ADDENDUM NO. 1

for CSP #250086

Org 208 Seagoville Elementary School – Addition and Renovation

Dallas Independent School District
April 27, 2026

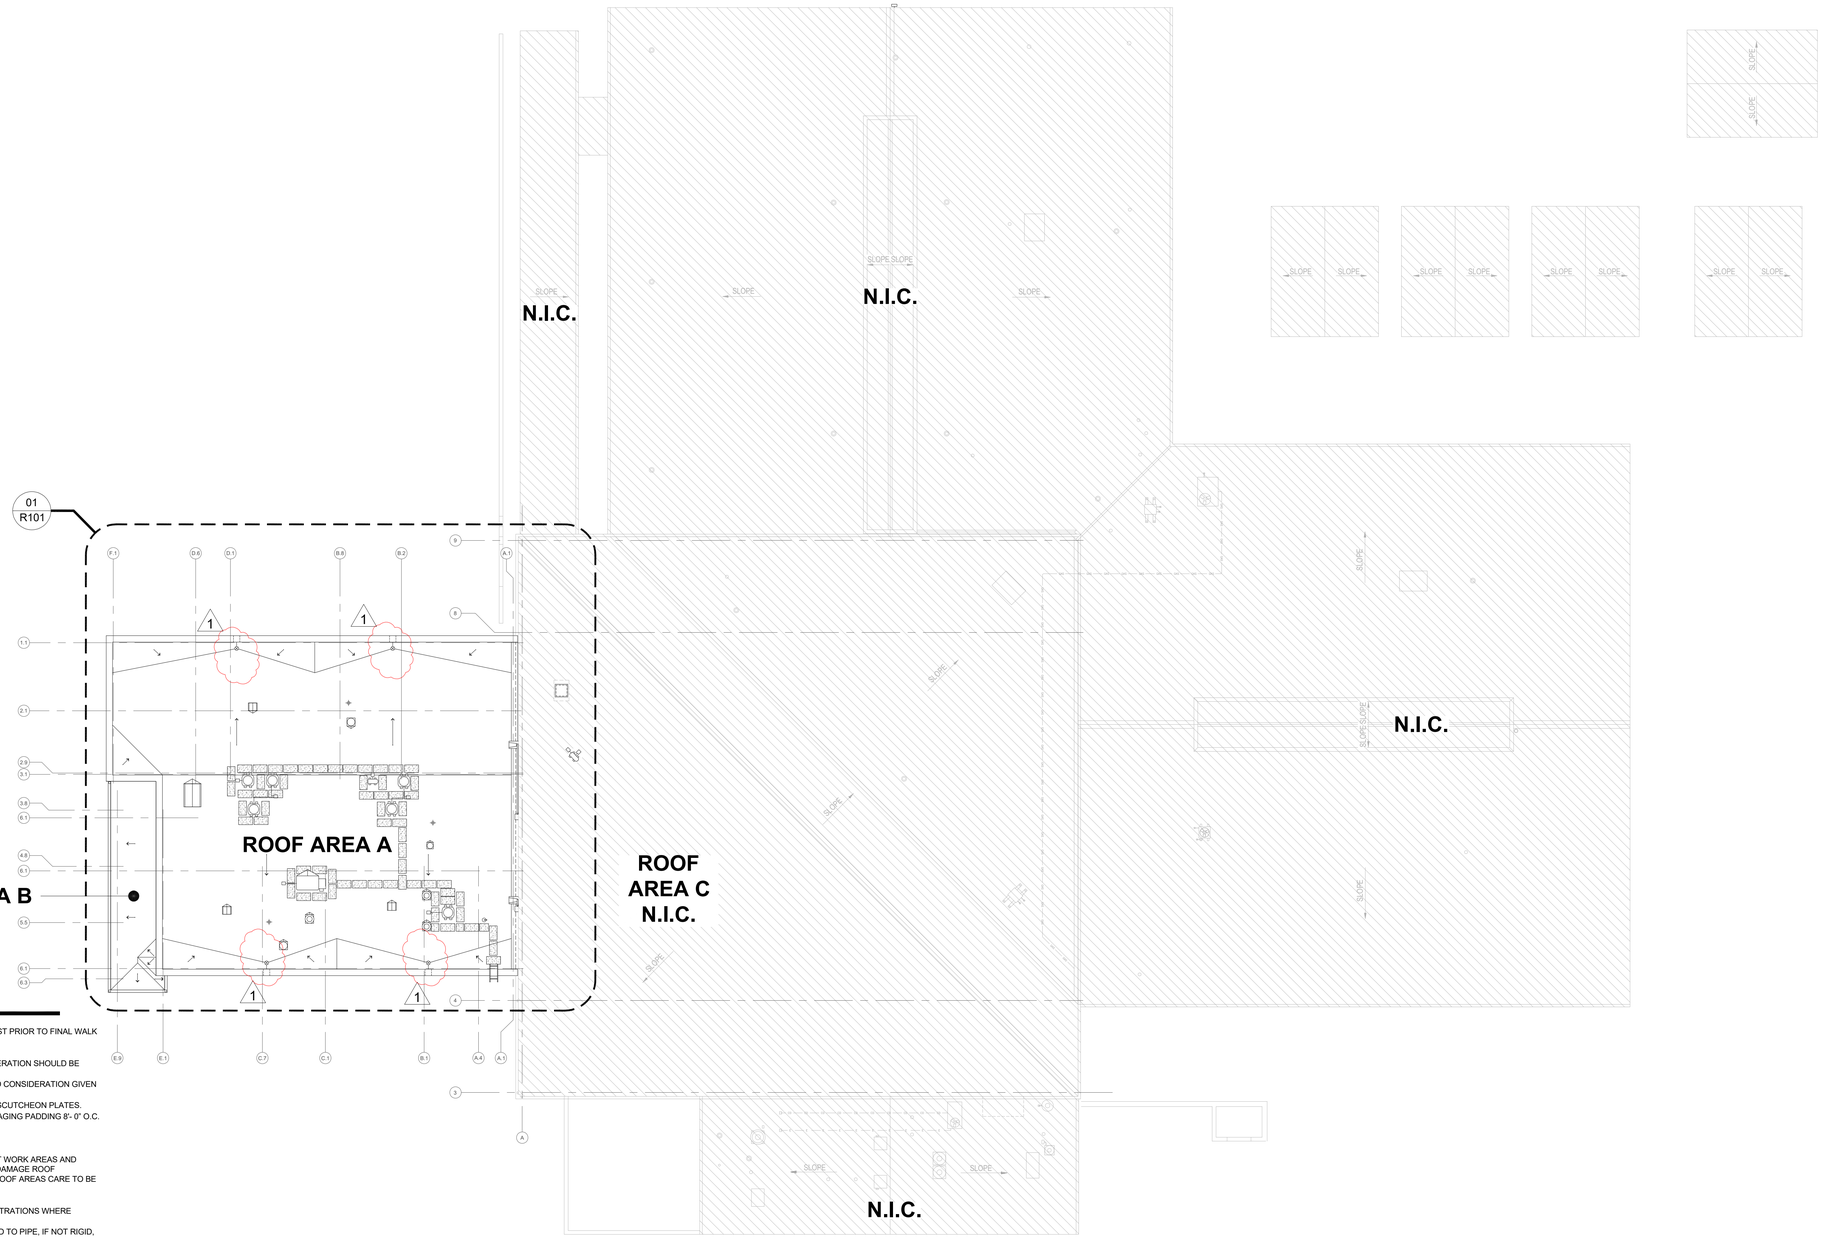
ITEM NO. 8 R100 – OVERALL CONSTRUCTION ROOF PLAN

1. Removed all storm rated overflow roof drains.
2. Added an overflow through wall scupper at each primary drain.

01 PARTIAL CONSTRUCTION ROOF PLAN

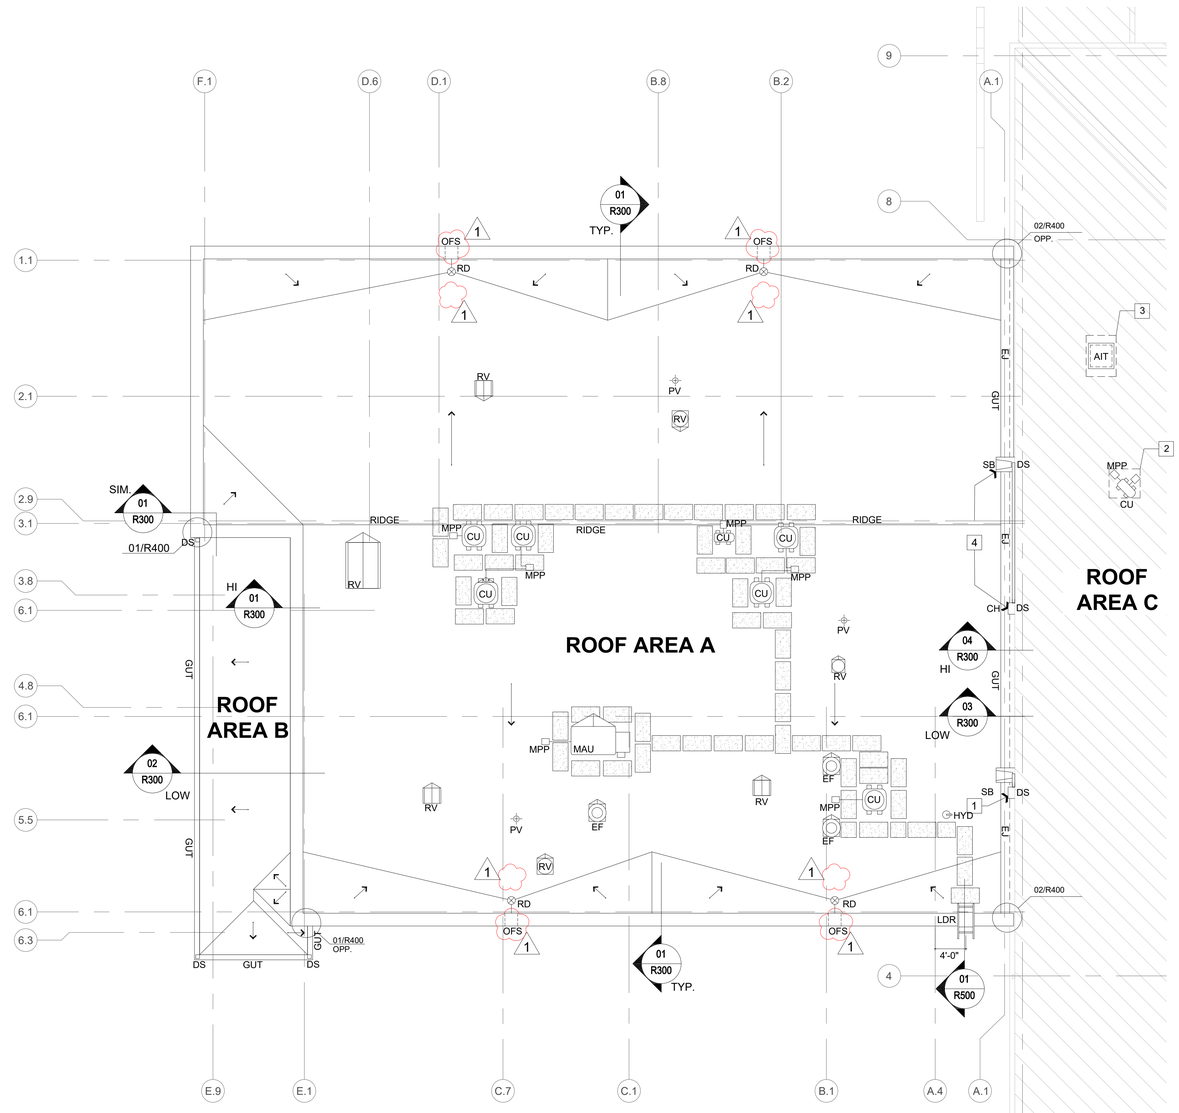
ITEM NO. 9 R101 – PARTIAL CONSTRUCTION ROOF PLAN

1. Removed all storm rated overflow roof drains.
2. Added an overflow through wall scupper at each primary drain.
3. Revised construction legend to call for overflow scupper referencing new detail in lieu of storm rated overflow drain.
